**VIRTUAL MEETING OF THE BIRMINGHAM PLANNING BOARD**  
**WEDNESDAY, MAY 13, 2020**  
**7:30 PM**

**CITY OF BIRMINGHAM  
VIRTUAL REGULAR MEETING OF THE PLANNING BOARD  
THURSDAY, APRIL 22, 2020**

**1. 35001 Woodward (Parking lots & Hunter House) – Revised Preliminary Site Plan & Community Impact Study Review to allow construction of a new 5 story mixed use building containing retail, office and residential uses.**

FIRST  
FLOOR PLAN

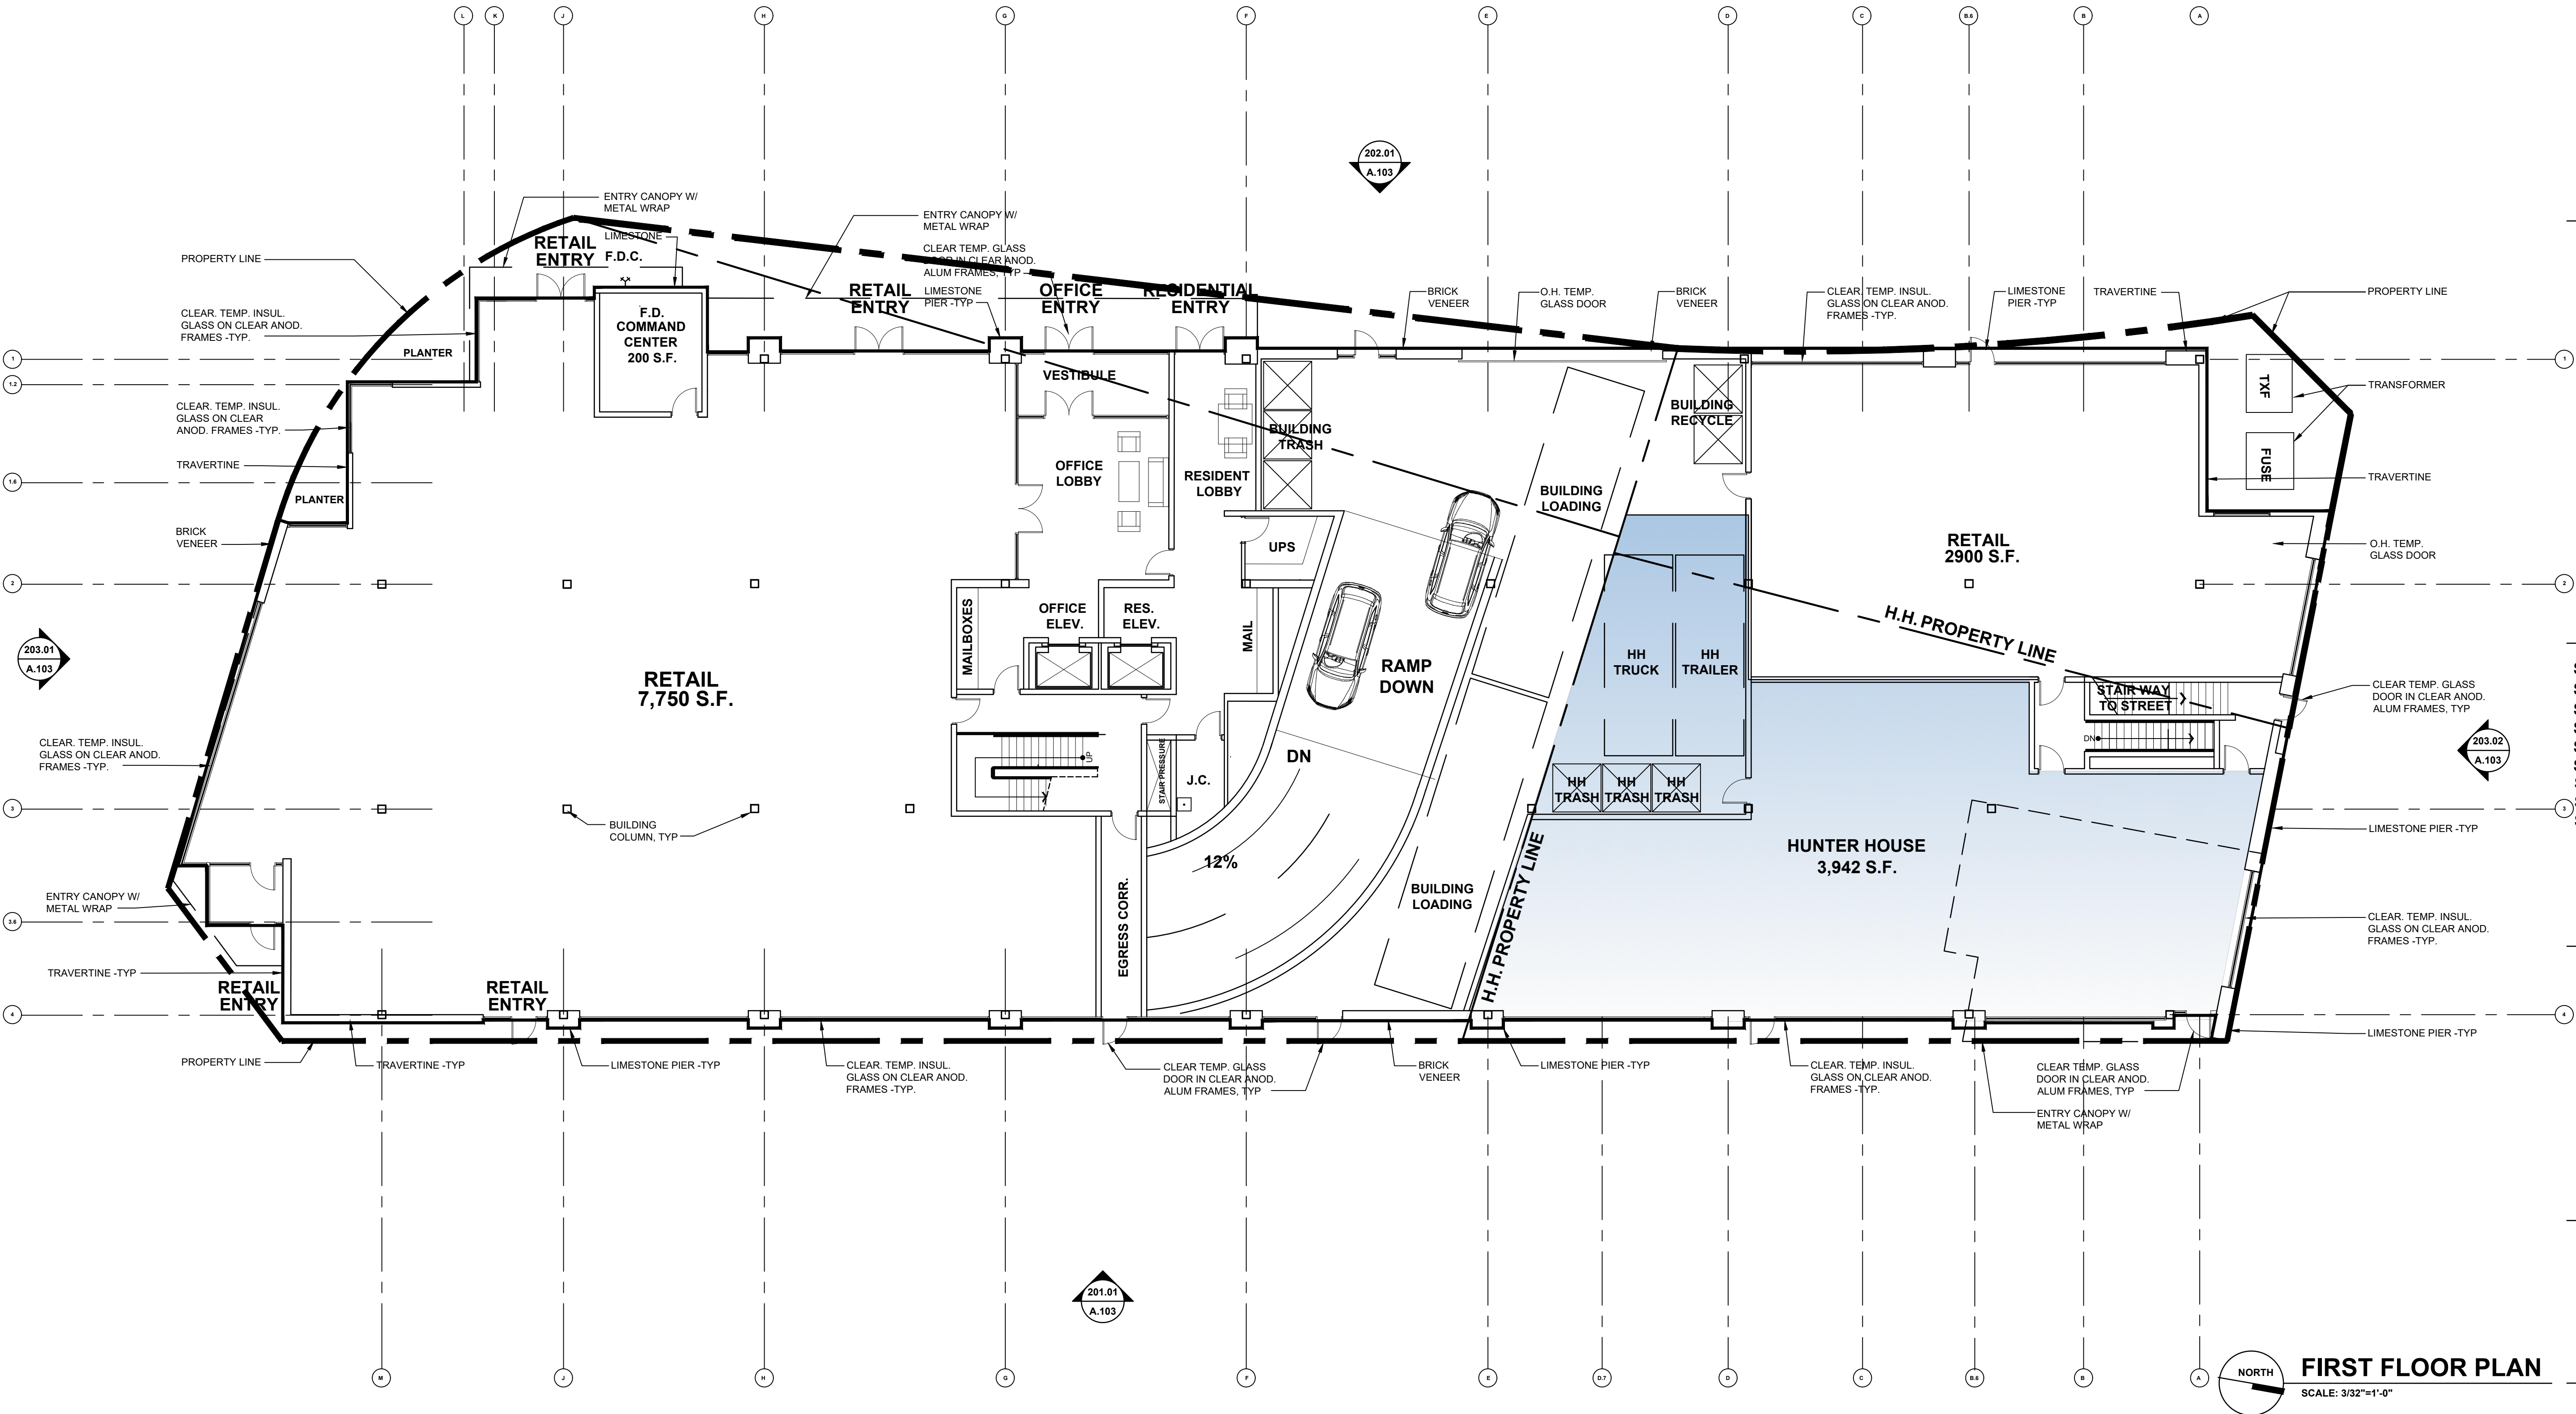
- 8) In all cases, delete the term 'Hunter House' from drawings and any text.

- 9) Approved plans include the first floor plan on sheet A101, with the revision date 4-3-20.
